Change Notification #: 113376 - 00
Change Title: Intel® Server System R1208GZ4GC
PCN 113376-00, Product Design
Update the Quick Reference Label and
BIOS/ME/BMC/FRUSDR Firmware
Date of Publication: November 05, 2014

Intel is implementing the following changes on the Intel® Server System R1208GZ4GC:

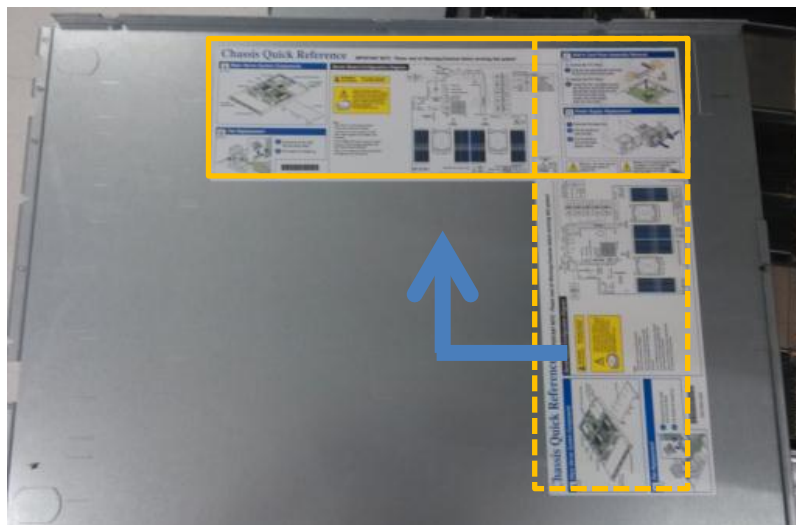
1. Rotate the orientation of the Quick Reference Label by 90 degree. The new location of the label is above the power supply unit cage and the air duct. Please see the figure below for reference.
